Lone Tree City Council Agenda Tuesday, March 15, 2016

Project Name: RidgeGate Section 15, Filing 19, Lot 3-A
Preliminary Plan (Urban Villas)

SUBJECT: RidgeGate Section 15, Filing 19, Lot 3-A
Preliminary Plan, Project File #SB15-98R

Graphic + comments from Daryl Heskin

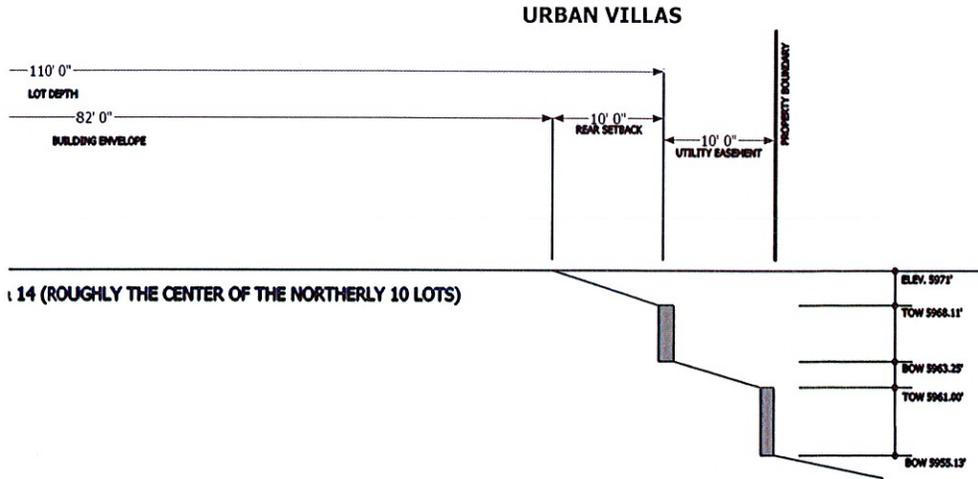
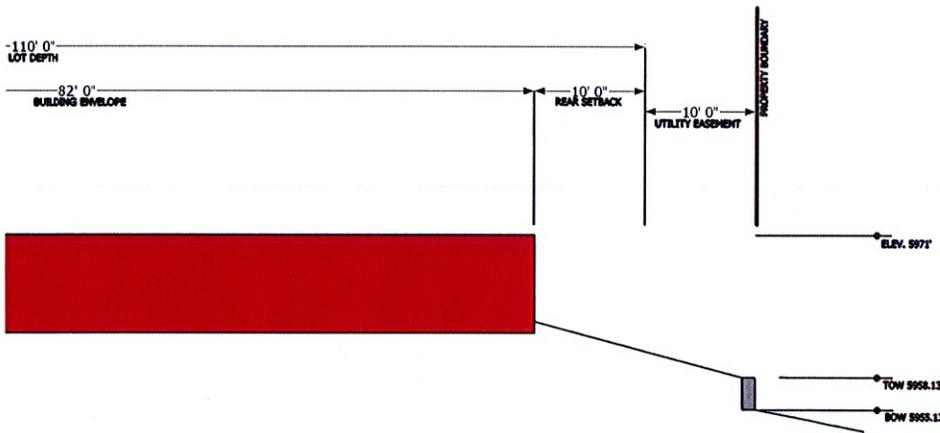
The above cross section of the site shows a section between lots 13 & 14 which are in the approximate center of the northerly building. The drawing is to scale and shows the steep grades in the "back yard" and in the utility easement.

The grade 5971' comes from the front of the unit at property line. I had to assume that it is somewhere near the garage/first floor level.

The lower drawing shows same cross section except the lower drawing shows a unit with a lower level reducing the height of the retaining walls.

With that said; my comments/questions are:

Essentially, Mr. Heskin observes that if we incorporated walk-out basements in the homes, we could use the foundations to take up a lot of the grade on the site, and thus reduce the height of the retaining walls in the rear. He is correct, however, from the beginning of the development of our concept, we intended to build three-story homes, with slab on grade construction, without walk-out basements.

This building form was chosen for several reasons, including the narrow 40' lots which needed multiple story houses in order to get enough square footage; the 40' wide lots with front-load garages makes it difficult to get adequate square footage on the main floors, necessitating two floors above the ground floor; three-story homes take best advantage of the views to the west; the site requires a lot of costly dirt export, and walk-out homes would add to this already significant export quantity and cost. With this said, we've realized from the beginning that homes with walk-out basements would reduce the height of the walls in the rear, but we consciously chose not to build what would be four-story homes (three plus the walk-out level).

The cross section assumes the foundation of the building is on the rear setback line which will not be the case. The rear of the lot will be flatter than what he is showing (where he shows 5971, it should be more like 5969). The grade change on our plan is about 3' over 82' from front of unit to rear of lot (5971 near front of unit to 5968 at rear lot line).

Sheet 1 – Title Sheet

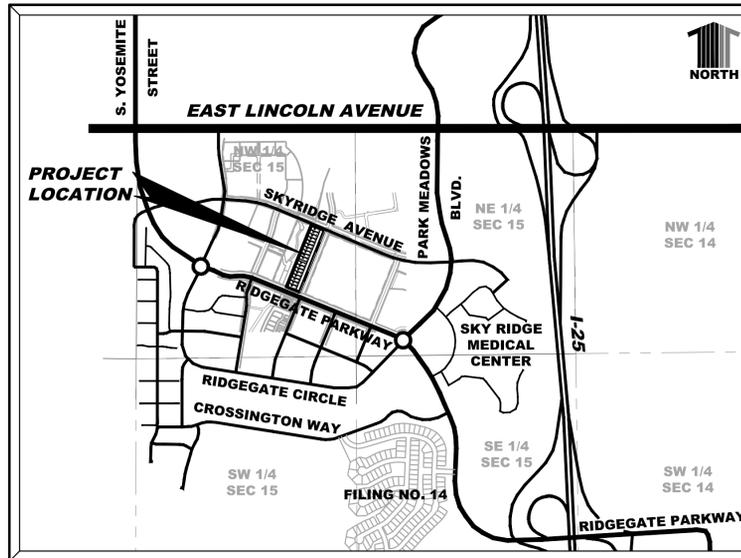
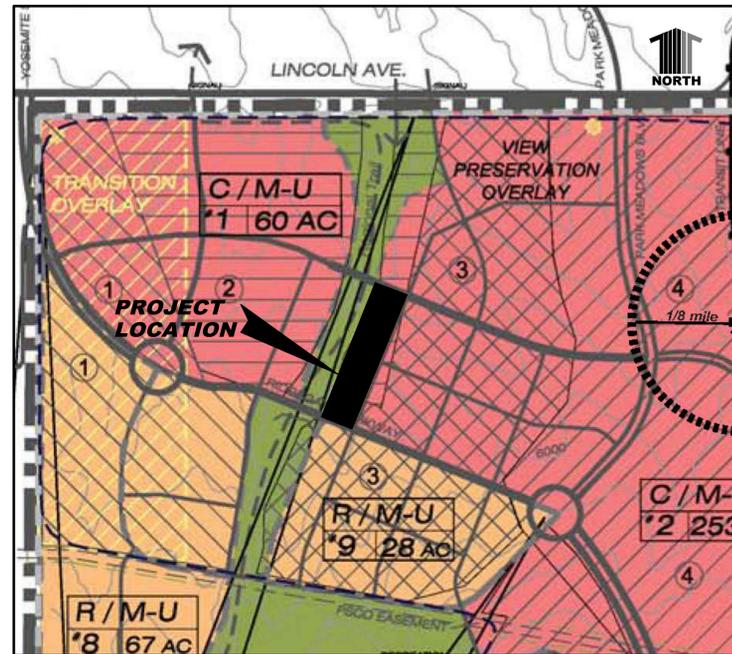
1. Streetscape Diversity Requirements – Encroachments Note B, 2nd line: Revise "...eight (8) into..." to "...eight (8) feet into ...".
2. The Typical Private Drive Section shows an attached 4-ft wide sidewalk. As shown on Sheet 2, this walk extends across the full width of the site, and appears to tie into the public sidewalks along Sky Ridge Avenue and Ridgegate Parkway. Typically, minimum width to provide adequate turning movement(s) for ADA accessibility is 5 (foot). We would recommend consideration to make this proposed attached walk 5-foot wide.

- 2) Please correct the Lot number in the title, in the title block at the bottom of each sheet and in any other reference to the original Lot number to: 3-A. (per the recorded Plat Correction Certificate)
- 3) Please correct the acreage of the site in the title to: 3.01. (per the recorded Plat Correction Certificate)
- 4) Please revise the Planning Project Number to: SB15-98R.
- 5) The areas and percentages in the Tract Summary and Development Statistics tables will have to be revised, or confirmed, due to the change in the boundary on Sheets 2, 3 and 4, per the boundary of the Lot, shown in the recorded Plat Correction Certificate.
- 6) Please confirm the information in the Development Standards table as it currently doesn't match the lot information shown on Sheet 2.

1. Streetscape Diversity Requirements - Encroachments Note B, 2nd line: Revise "...eight (8) into..."to "...eight (8) feet into ...".
Response: The word "feet" has been added, as requested to note B.

2. The Typical Private Drive Section shows an attached 4-ft wide sidewalk. As shown on Sheet 2, this walk extends across the full width of the site, and appears to tie into the public sidewalks along Sky Ridge Avenue and Ridgeway Parkway. Typically, minimum width to provide adequate turning movement(s) for ADA accessibility is 5 (foot). We would recommend consideration to make this proposed attached walk 5-foot wide.

Job Number BERKELEY RG F19L3
Date MARCH 7, 2016
Sheet 2 of 4

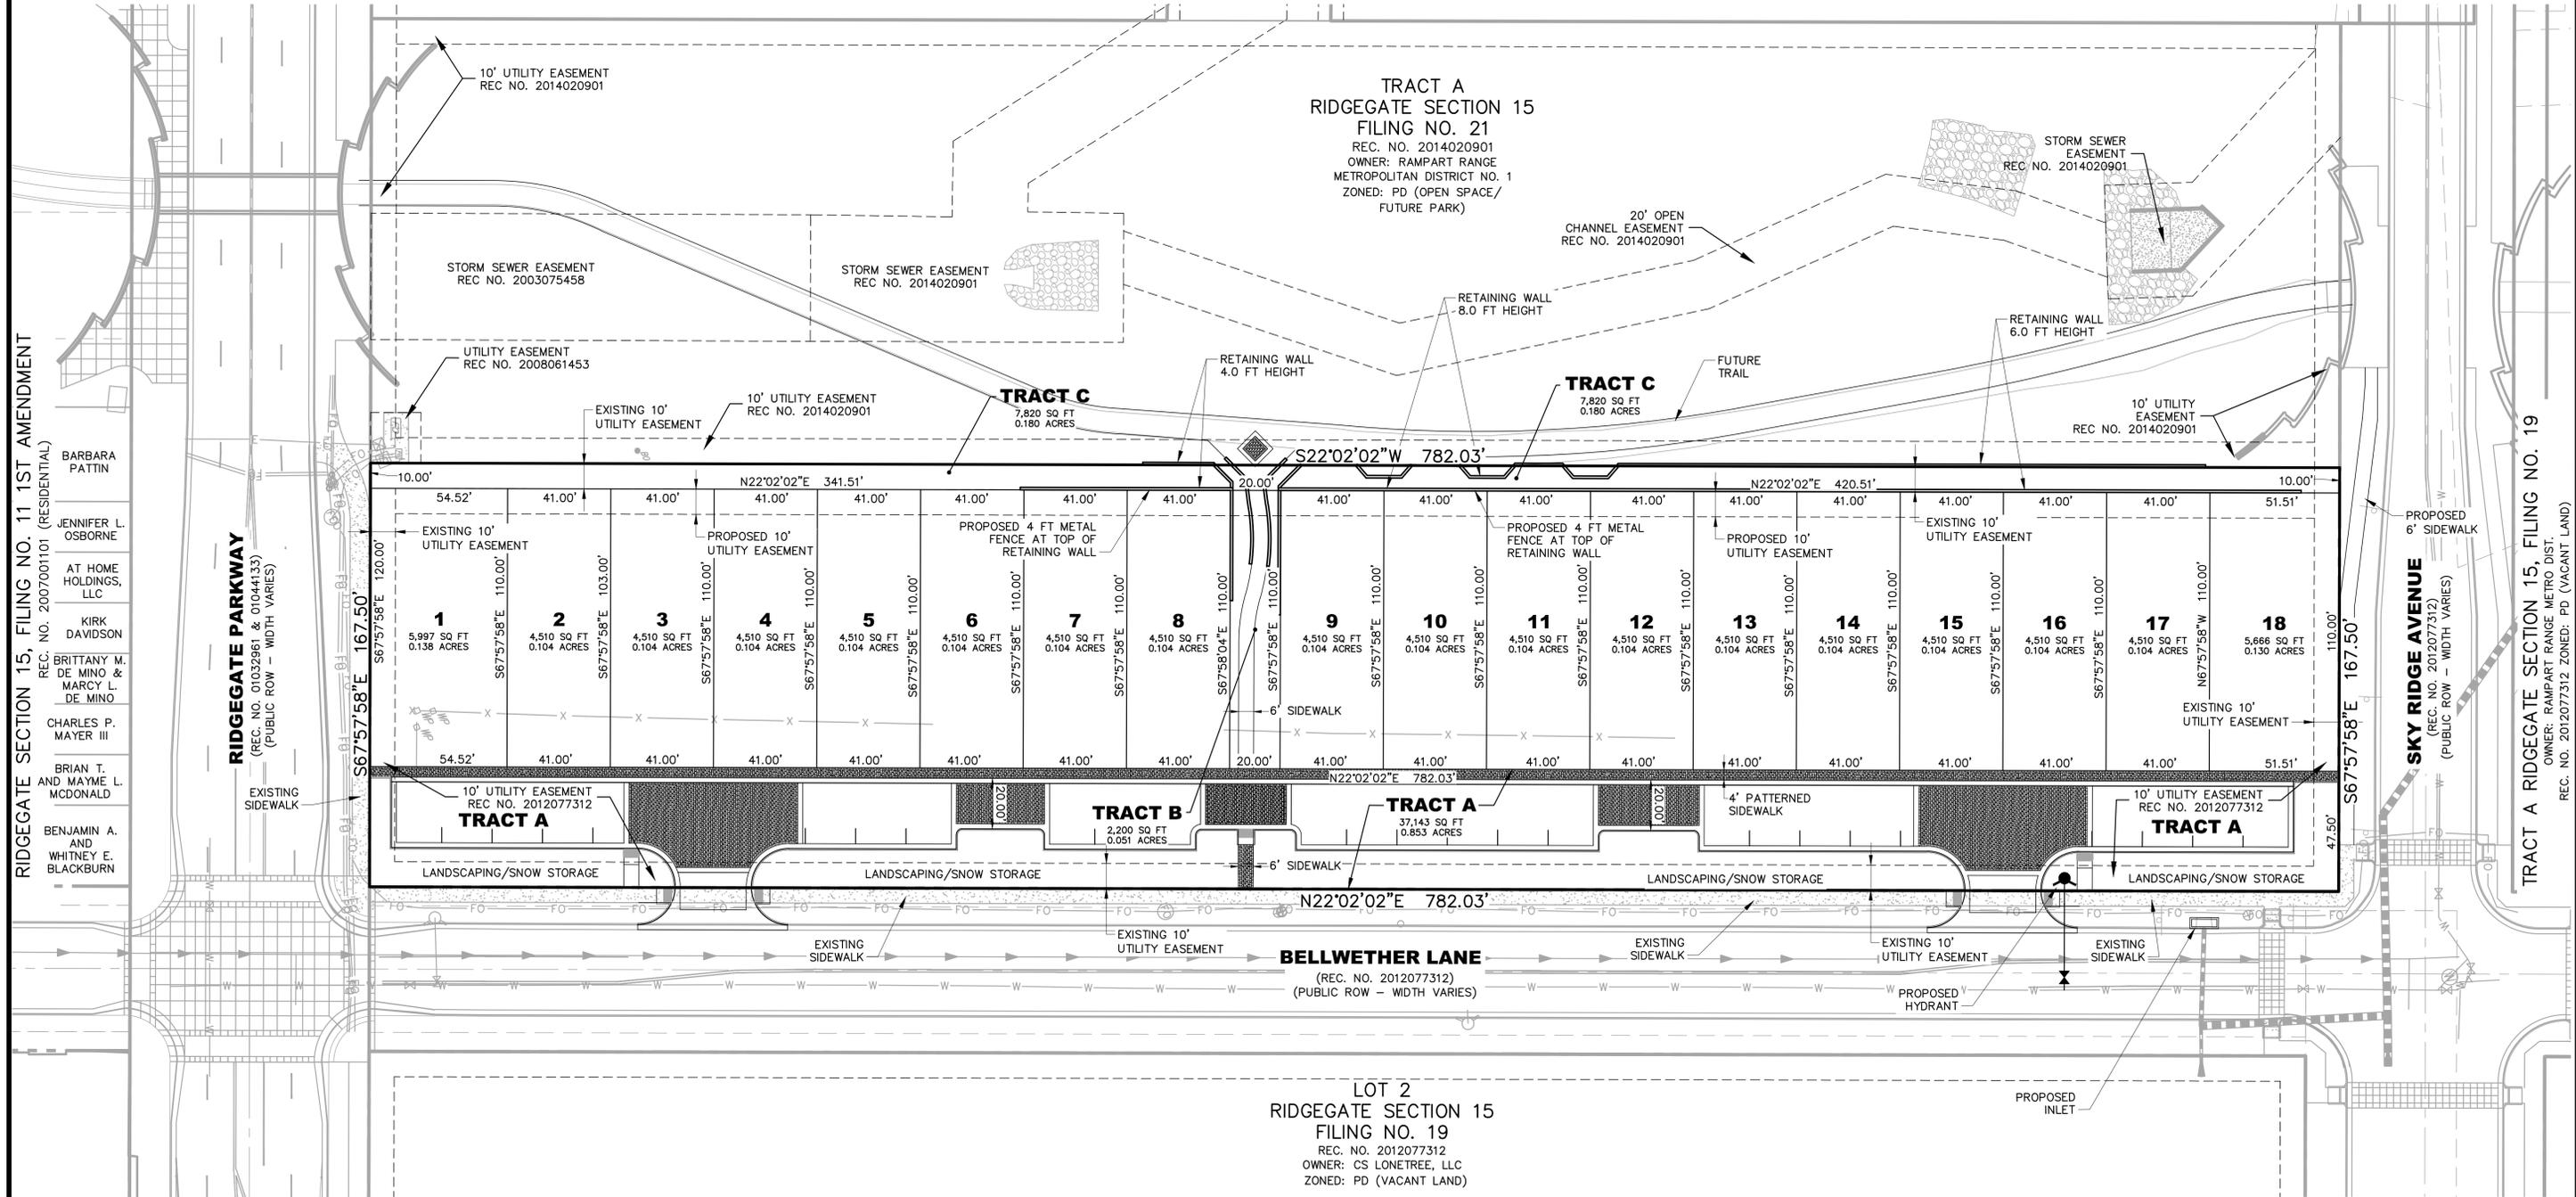
- 7) Please correct the boundary of the site (at the Northwest corner) per the recorded Plat Correction Certificate which will require changing the acreage on Lot 18 and Tract C.
- 8) The acreages of Tracts A and B don't match those shown in the Tract Summary on Sheet 1. Please correct.
- 9) Please add the recording information to the labels of the existing easements, including the storm easement that appears to exist in the Northwest corner of Lot 18, as indicated on the Plat of Filing No. 19. [Article III, Section 17-3-60 (2) e.]

8. The acreages of Tracts A and B don't match those shown in the Tract Summary on Sheet 1 Please correct.
Response: Understood, we are reviewing these issues.
